3070-97

# Modification Available Performance Enhancement Service Note

## Keysight i3070 Series 5 Inline In-Circuit Test System

The Problem - ESD Belt Guide Bar replacement for i3070 4 module Inline ICT

Figure 2: 3mm board edge support

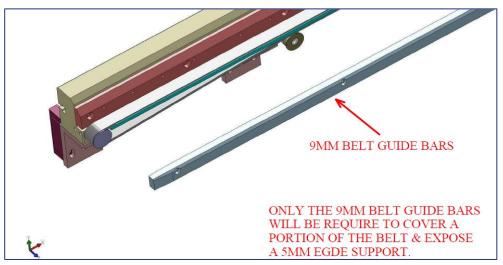
The 4-module inline In-circuit tester (ICT) conveyor belt guide bar used to manage the conveyor belt exposure to support 3mm, 5mm and 10mm (Figure 2 - 4) of printed circuit board edge.

The existing conveyor belt guide bars can support anti-static and electrostatic discharge (ESD) belts. All ESD belts are within the material specification, but some of the ESD belts thickness are within the high side of the material tolerance specification causing the gap in between belt guide bar and conveyor rail become smaller.

If you have used/changed to the ESD belts, the recommendation is to replace with the latest designed belt guide bar. It has new oval shape screw hole (Figure 1B) to accommodate ESD belts thickness that are within the high side of the material tolerance specification.
